**NOTICE OF DECISION - CHEHALEM AQUATIC CENTER
CONDITIONAL USE PERMIT/DESIGN REVIEW/CODE ADJUSTMENT
CUP-16-001/DR2-16-001/ADJC-16-001**

PLANNING COMMISSION ORDER 2016-20

AN ORDER APPROVING CONDITIONAL USE PERMIT/DESIGN REVIEW/CODE ADJUSTMENT CUP-16-001/DR2-16-001/ADJC-16-001 FOR AN EXPANSION OF THE CHEHALEM AQUATIC AND FITNESS CENTER AT 1802 HAWORTH AVENUE, YAMHILL COUNTY TAX LOT 3217CA-1200

Exhibit “A” to Planning Commission Order 2016-20
Findings –File CUP-16-001/DR2-16-001/ADJC-16-001
Chehalem Aquatic and Fitness Center

F. REVISED SITE PLAN – 148 PARKING SPACES

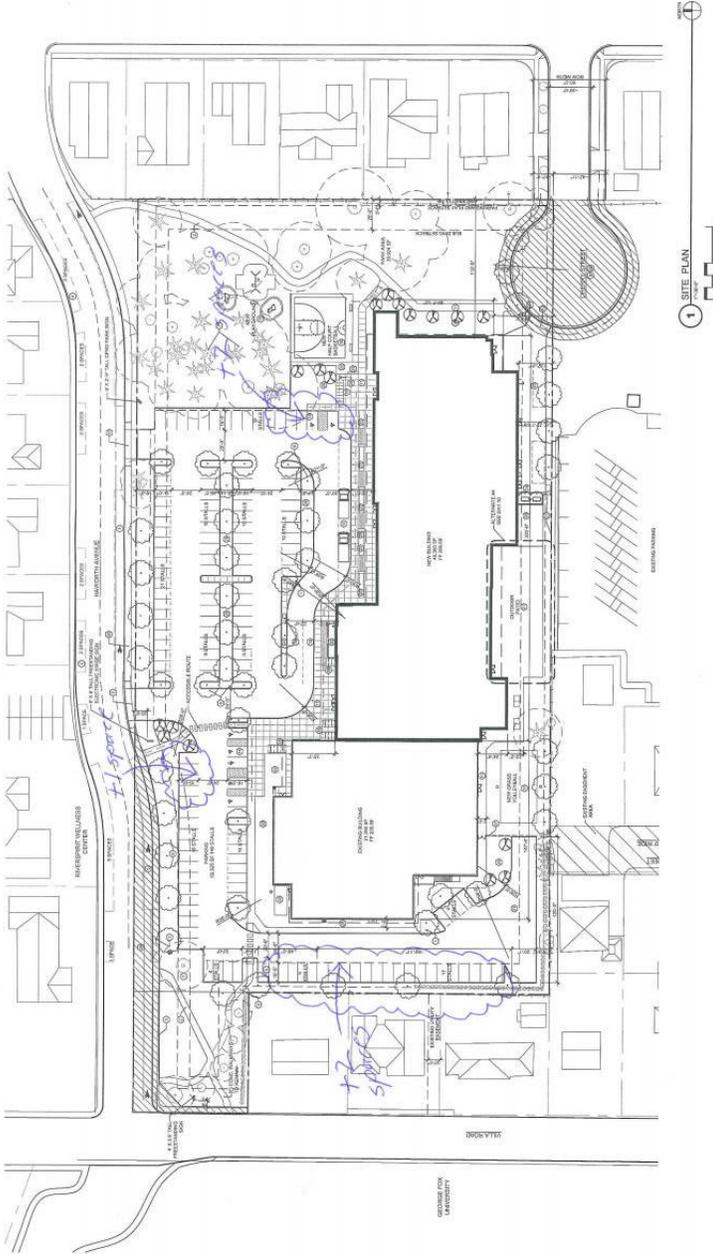
Finding: The applicant has requested a reduction in the amount of required off-street parking from 197 spaces to 148 spaces, and believes that amount will be adequate in relation to user demands if some traffic demand management steps are taken.

As noted previously in the design review findings, the peak parking demand is expected to be 197 spaces. This peak demand is expected to occur 4-5 times per year during regional swim meets. The applicant believes 148 spaces will be adequate the remainder of the time.

Number of spaces: The maximum code adjustment allowed is a 25% reduction. 25% of 197 spaces is 49 spaces, so approval of a code adjustment could reduce the amount of required off-street parking to 148 spaces.

Retaining natural features on-site: The existing site has many mature trees, and the applicant has tried to preserve as many as possible due to strong public demand to save the trees. If the applicant had to provide 49 additional parking spaces on the site then nearly all of the mature trees would need to be removed. Approving the code adjustment would help retain natural features on the site.

Approval of a code adjustment to reduce the amount of off-street parking from 197 spaces to 148 spaces will provide adequate off-street parking in relation to user demands as conditioned. During peak events, the applicant must make use of the shared parking agreement with the high school, and must apply to the City Engineer for on-street parking approval along the Haworth Avenue frontage.

1. The City Engineer will allow the applicant to apply for temporary on-street parking approval during major facility events (expected to be 4-5 times per year) to provide parking to event participants along the south side of Haworth Avenue. Parking in the bike lane would not be available at other times of the year.
2. During peak events, the applicant must make use of the shared parking agreement with the high school, and must apply to the City Engineer for on-street parking approval along the Haworth Avenue frontage.
